Access Compliance Report

Public Rights-of-Way

Intersection ID: 27333	Main Street: BALLANTYNE_MEDICAL_PL	Cross Street: N/A	Location: SW
ADA ID: 6F92B1000513	Ramp Type: Perp	Initial Pass/Fail: Fail	Overall Compliance: No
Severity Score: 1.25			
Codes/Mitigation Info/Possible Solution		Field Measurements/Component Compliance

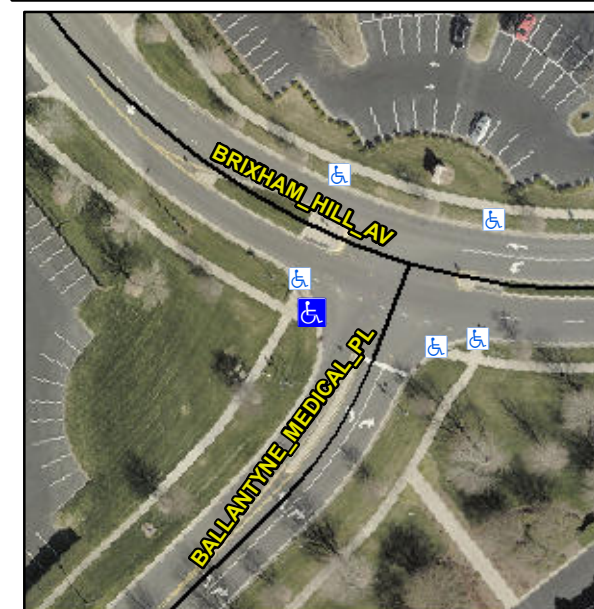
R304.5.3

Compliance	Description	Data	Compliance	Description	Data
N/A	Ramp Length (in)	110.0	Yes	Ramp Slope (%)	5.3
Yes	Ramp Width (in)	59.0	No	Ramp XSlope (%)	2.3
N/A	Flare Type LT	N/A	N/A	Flare Type RT	N/A
N/A	Flare Slope LT (%)	N/A	N/A	Flare Slope RT (%)	N/A
N/A	Flare Traversable LT?	N/A	N/A	Flare Traversable RT?	N/A
N/A	Landing Length (in)	N/A	N/A	DWS Provided?	N/A
N/A	Landing Width (in)	N/A	N/A	DWS Contrast?	N/A
N/A	Landing Slope (%)	N/A	N/A	DWS Length (in)	N/A
N/A	Landing X Slope (%)	N/A	N/A	DWS Full Width?	N/A
N/A	Landing Curb? (Y/N)	N/A	N/A	DWS Offset (in)	N/A
N/A	Shared Landing?	N/A			
N/A	Gutter Ponding?	N/A	N/A	Gutter Slope (%)	N/A
N/A	Gutter Lip Ht (in)	N/A	N/A	Gutter X Slope (%)	N/A
N/A	Painted X Walk1?	No	N/A	Painted X Walk2?	N/A
	X Walk 1 Direction	To E		X Walk 2 Direction	N/A
N/A	X Walk 1 Width (in)	N/A	N/A	X Walk 2 Width (in)	N/A
	X Walk 1 Slope (%)	3.4		X Walk 2 Slope (%)	N/A
	X Walk 1 X Slope (%)	2.4		X Walk 2 X Slope (%)	N/A

Remove & Replace Entire Ramp.
